Change of Specification for Plug-in Type MCCB & ELCB

We inform that the screws for Plug-in types are changed as follows.

| Relevant Components | Before | After |
|---|--|--|
| <p>Ex.) NF63-CV 3P PM-N (Rear side)</p>  <p>Plug-in terminal</p> | <p>Without fluorine oil.</p>  <p>Plug-in terminal</p> | <p>Apply fluorine oil.</p> <p>Plug-in terminal</p>  <p>Apply area</p> |

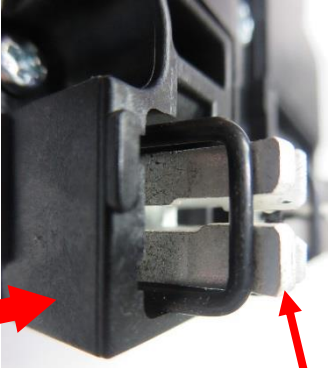
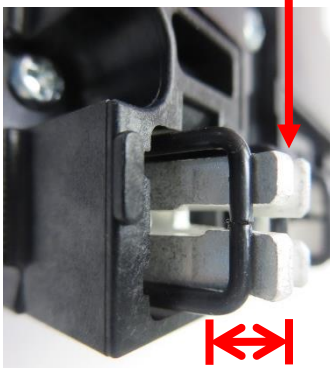
For improve the operability of plug in and out

Apply fluorine oil to the Plug-in terminal.
